Lift and Escalator Industry Association

LIFTWISE LTD CORRECTIVE ACTION NOTICE HS-502/A

CORRECTIVE ACTION NOTICE

ELECTRICAL ANTI-CREEP SYSTEM

The circuit before and after modification is shown in diagrams 1 and 2, on the reverse of this notice.

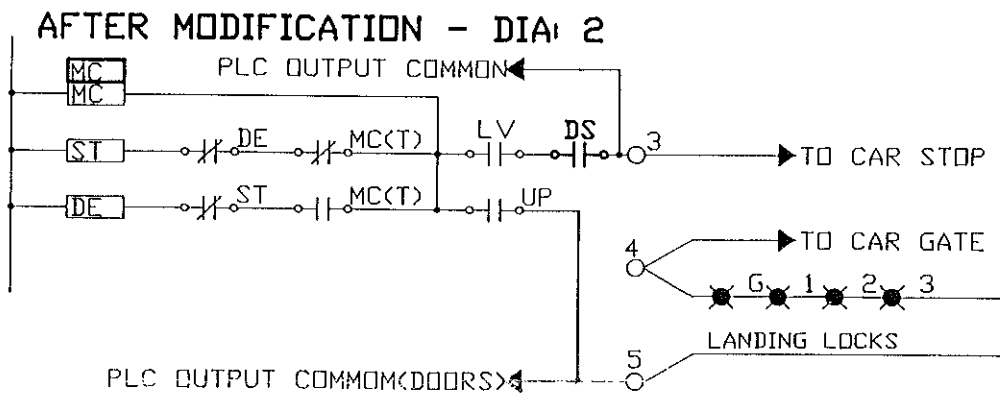
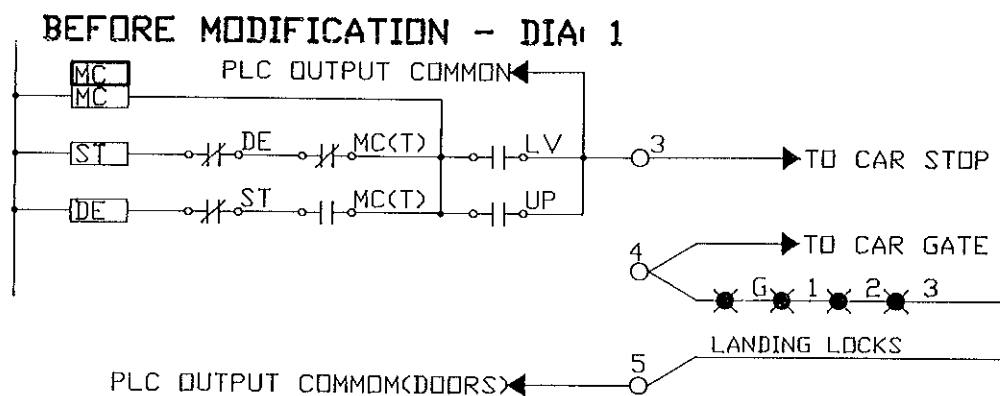
Although **No** operating malfunctions have been reported, we have identified a potential risk in the design of our hydraulic Lift anti-creep circuit.

The circuit employs one independent electrical device for motor contactor control during anti-creep re-leveling. Should this device fail to open, the Lift could continue to re-level up, causing a hazardous situation.

The circuit should be modified by the introduction of a further set of relay(DS) contacts, in series with the existing levelling relay(LV) contacts, which feed the MC contactor coil. The feed for the UP relay contacts should also be moved from terminal 3 to terminal 5.

If a controller is identified, which does not have the standard motor start circuit shown in diagram 1, please submit Form HS-112\A-0798 to Liftwise and we will advise appropriate modifications, as necessary
